To: T10 Technical Committee
From: Rob Elliott, HP (elliott@hp.com)
Date: 25 April 2004
Subject: 04-115r1 SAS-1.1 Miscellaneous changes

Overview

This collects a variety of minor technical (or major editorial) changes, most of which have been highlighted as editor's notes in the last few revisions of SAS-1.1.

Figure 1 — Expander device [updated figure 12]

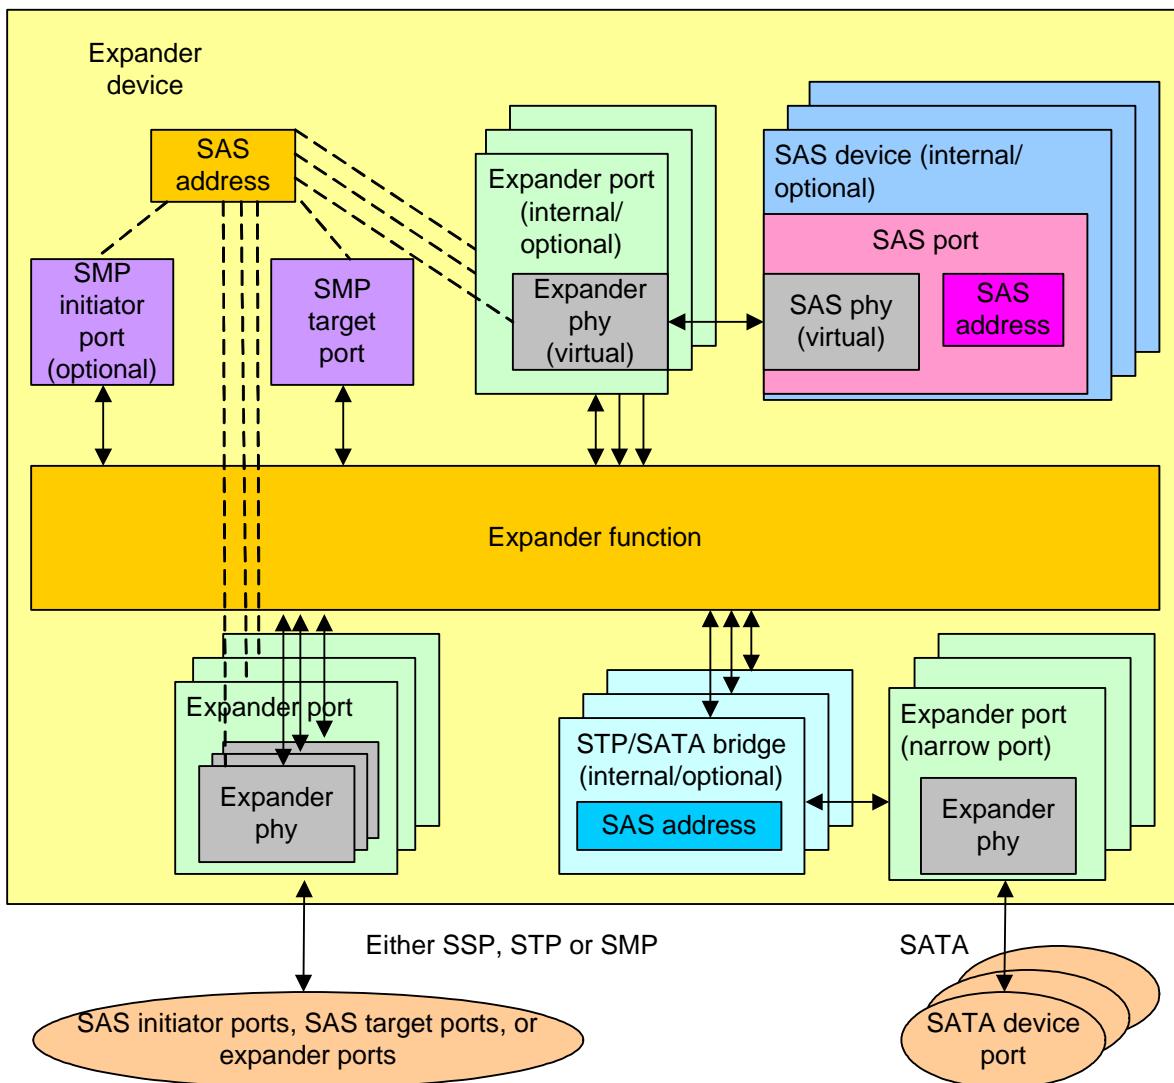
2 Clause 4 - add SMP initiator port to figure 12

Add an optional *SMP initiator port* to figure 12, since if present it shares the expander's own SAS address with the SMP target port. Also add some more phys to the ports in the picture and show the SAS addresses.

[**Figure 2 — Transmitting a repeated primitive sequence**](#)

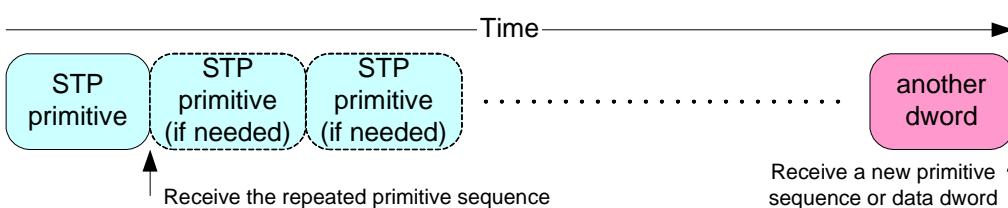
[Figure 2 shows an example of transmitting a repeated primitive sequence.](#)

Figure 4 — Transmitting a continued primitive sequence [figure updated]

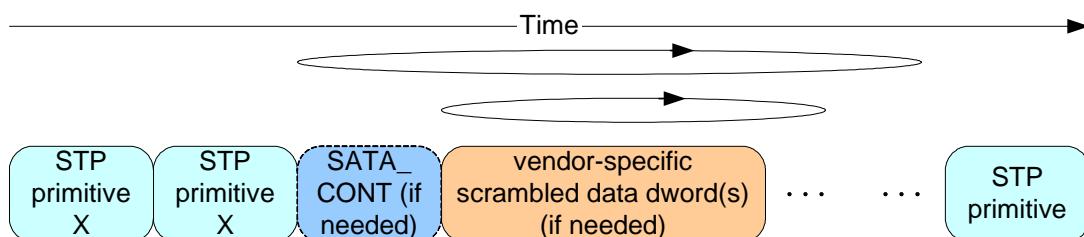
7.2.4.3 **Repeated** Continued primitive sequence

Primitives that form **repeated** continued primitive sequences (e.g., SATA_HOLD) shall be **sent transmitted** two times, then be followed by SATA_CONT (if needed), then be followed by vendor-specific scrambled data dwords (if needed). ALIGNs and NOTIFYs may be sent inside continued primitive sequences as described in 7.2.4.1. After the SATA_CONT, during the vendor-specific scrambled data dwords:

Figure 4 shows an example of transmitting a **repeated** continued primitive sequence.

Figure 5 — Receiving a continued primitive sequence

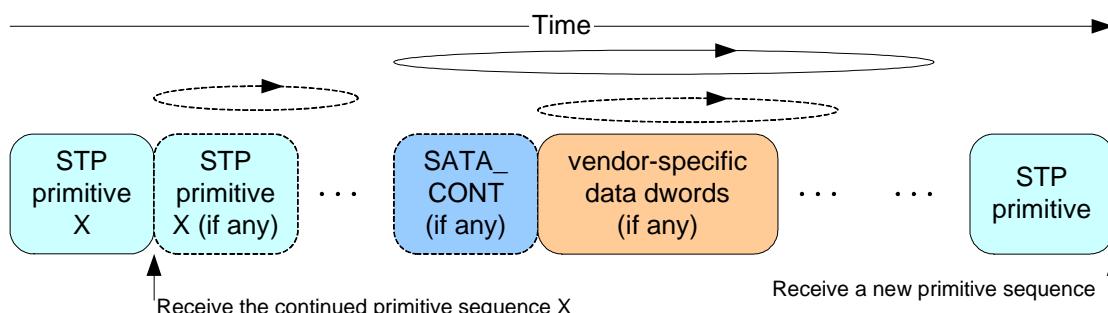
Receivers shall detect a continued primitive sequence after at least one primitive is received. The primitive may be followed by one or more SATA_CONTs, each of which may be followed by vendor-specific data dwords. Receivers shall ignore invalid dwords before, during, or after the SATA_CONT(s). Receivers do not count the number of times the continued primitive, the SATA_CONTs, or the vendor-specific data dwords are received; they are simply in the state of receiving the primitive.

Figure 5 shows an example of receiving a continued primitive sequence.

Figure 6 — Transmitting a continued primitive sequence [\[figure updated\]](#)

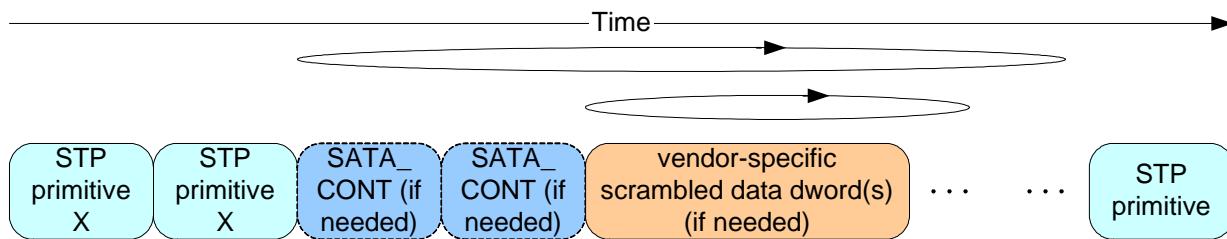
10 Clause 7.2 - allow sending two SATA_CONTs

The existing SAS and SATA requirement for sending the continued primitive at least twice tolerates single-bit errors in the primitive itself. Likewise, single-bit errors in the scrambled data don't matter. A single-bit error in the SATA_CONT itself, however, confuses the receiver, which sees a primitive followed by scrambled data.

In SAS, mention that STP ports may send two SATA_CONTs rather than one to survive a single bit error in SATA_CONT.

Figure 6 shows an example of transmitting a continued primitive sequence with two SATA_CONTs.

Editor's Note 1: as as, the transmit picture from the previous proposal allows for this (assume it loops on (SATA_CONT followed by data dwords) where no data dwords are included) so updating the picture might not be necessary.

Figure 103 — STP target port opening an STP connection [modified]

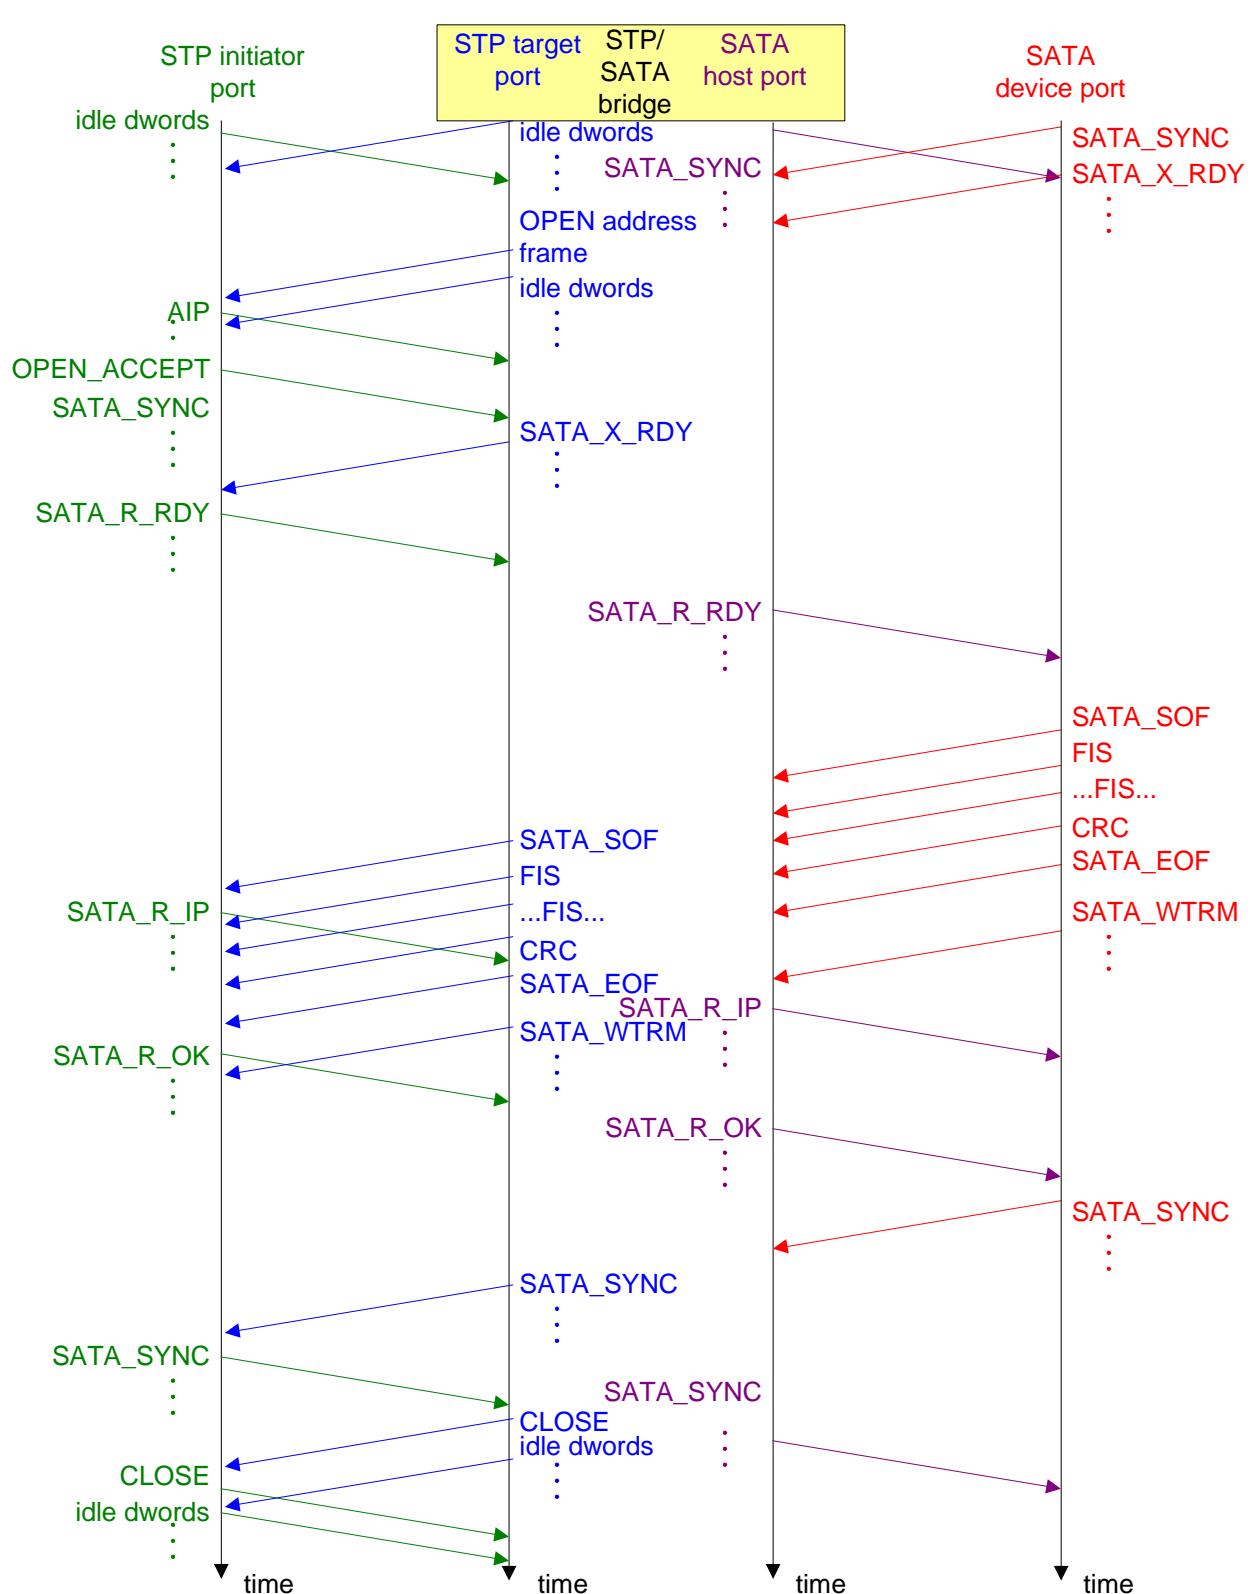
Figure 103 shows after sending OPEN_ACCEPT, an STP initiator continues to send idle dwords before sending SATA_R_RDY. Section 7.17.8 explicitly allows this.

Also, redraw figure 103 so it flows left to right rather than right to left.

[changed idle dwords to SATA_SYNC in what is now the top left]

The first dword that an STP phy sends inside an STP connection after OPEN_ACCEPT that is not an ALIGN or NOTIFY shall be an STP primitive (e.g., SATA_SYNC).
